**RE: Lot 24 Rancho Guadalupe
1616 Rancho Guadalupe Trail
Request for Permanent C.O. - Accepted
Engineers Stamp Date 11/21/14 (F13D002C)
Certification Dated: 8-13-15**

1616 Rancho Guadalupe Trail Grading & Drainage Certification

**Re: Lot 24 Rancho Guadalupe Subdivision
Grading and Drainage Plan
Engineer's Date 11-21-14 (F13D002C)**

**Re: Lot 24 Rancho Guadalupe Subdivision
Grading and Drainage Plan
Engineer's Date 10-16-14 (F13D002C)**

SITE PLAN
SCALE: 1"=10'

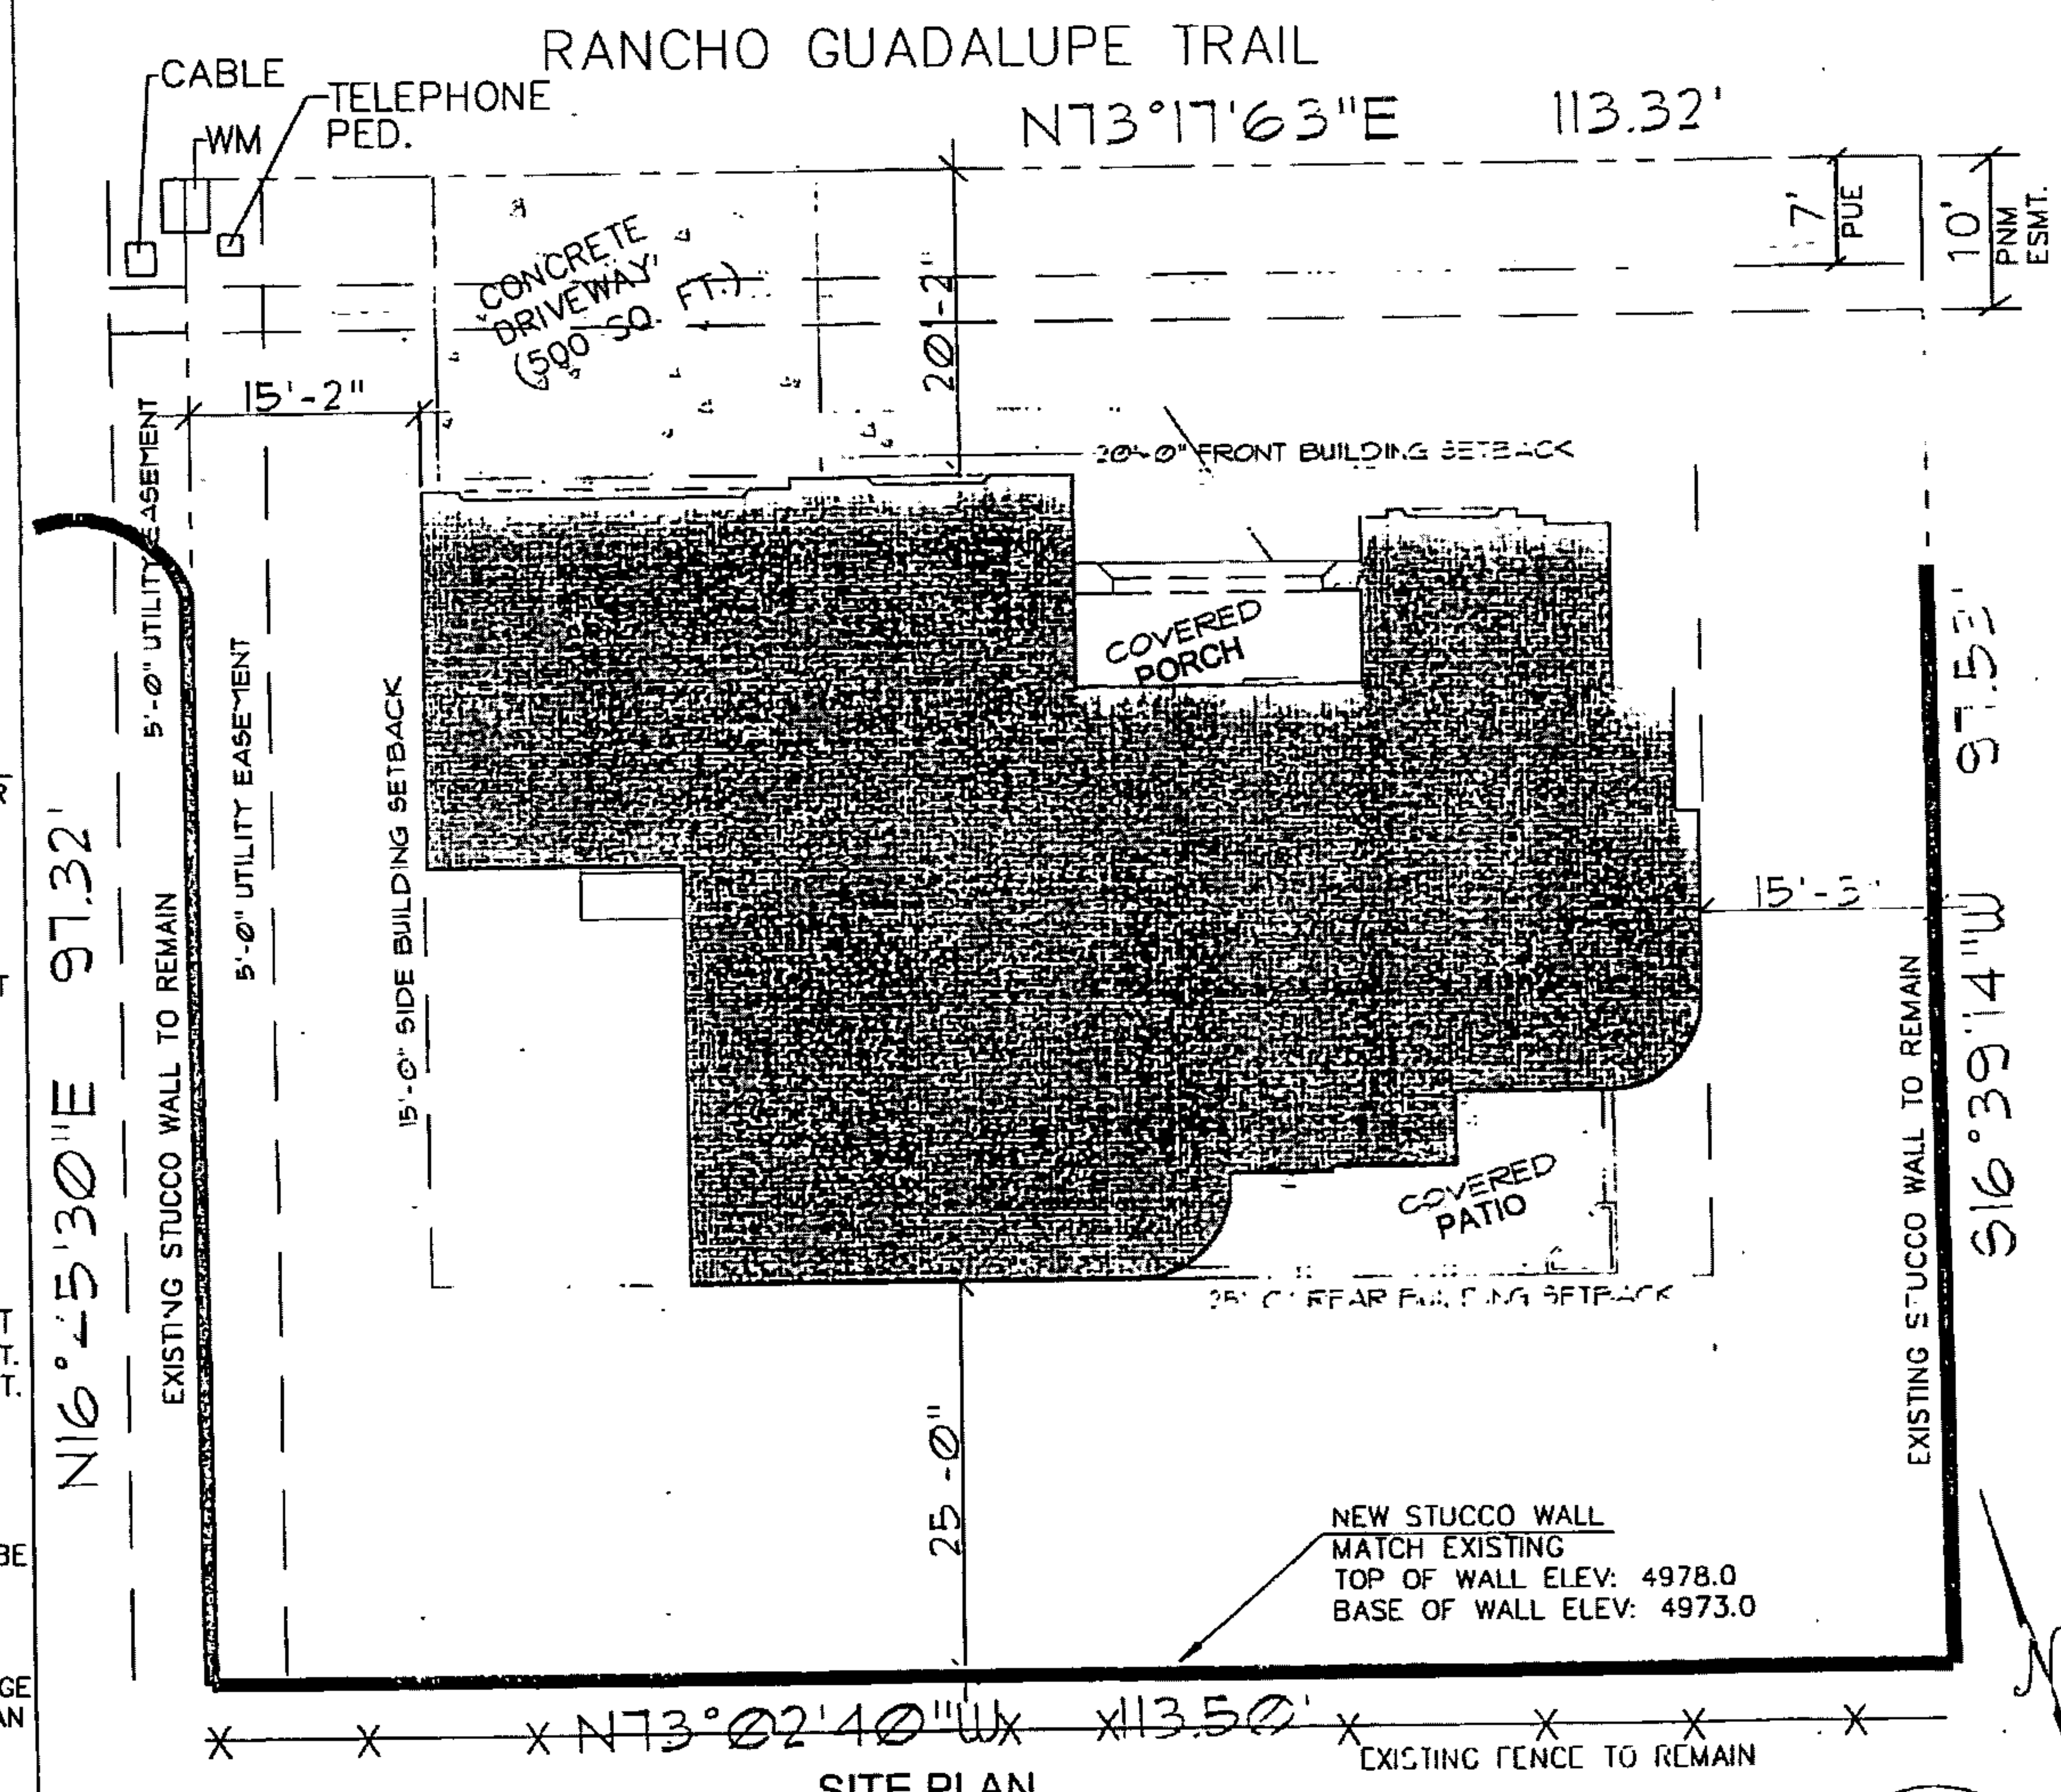
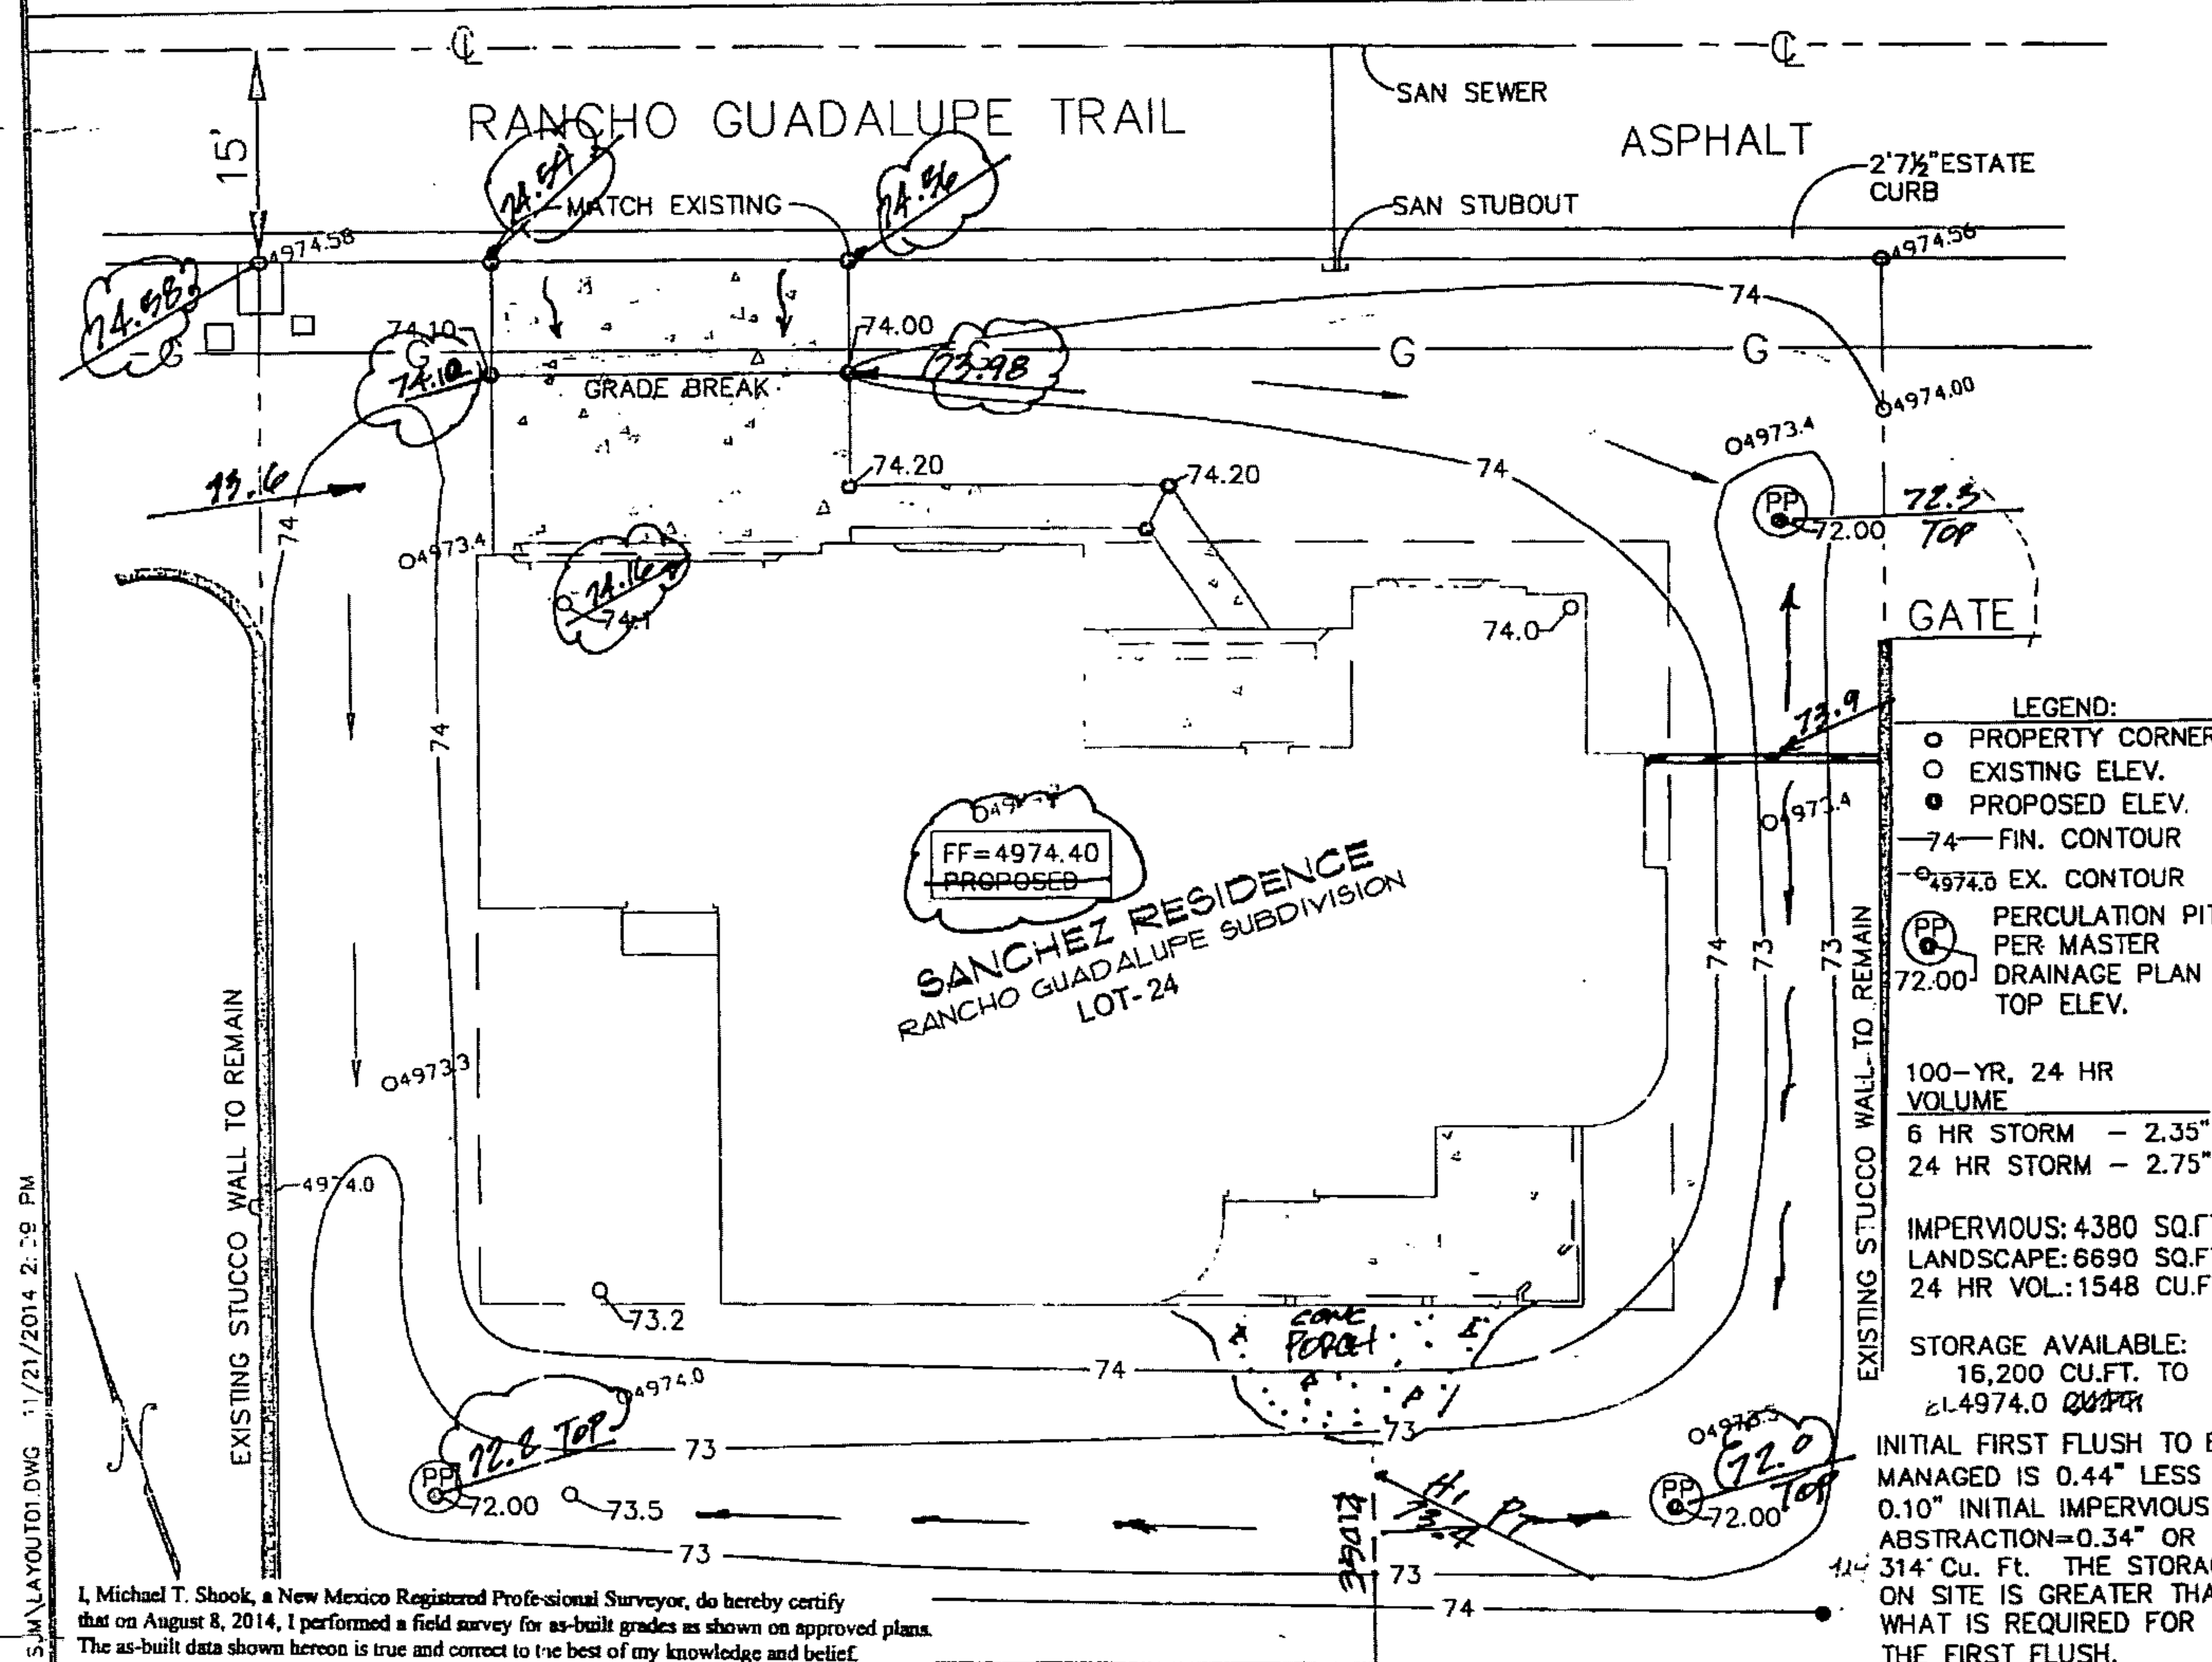
The correct First Flush amount is 0.34 times the impervious area of the site (4380 sf) which totals to 924 cf not 314 cf as stated on the plans. The ponding area is more than adequate for this. Please note this for future submittals to Hydrology.

1. Provide a percolation pit detail that is per the master drainage plan. The pit should release to the sand strata.
2. The First Flush was not discussed. Per the City Drainage ordinance, the 90th Percentile Storm Event, which is 44 inches, is to be managed. Reduce 0.44 inch by the 0.1 inch for the initial impervious abstraction in Table A-6 of Section 22 of the DPM. Multiply the remaining 0.34 inch by your impervious area. This is the amount of the First Flush necessary for the site. Show that amount on your plans. State that the capacity provided by the proposed ponding is greater than what is required for the First Flush.
3. The 74 contour is not addressed in the back. Is the back wall acting as a retaining wall or is there simply a steep grade?
4. Provide a discussion of the 100 Year Flood Plain.
5. Include a site map with the site identified.
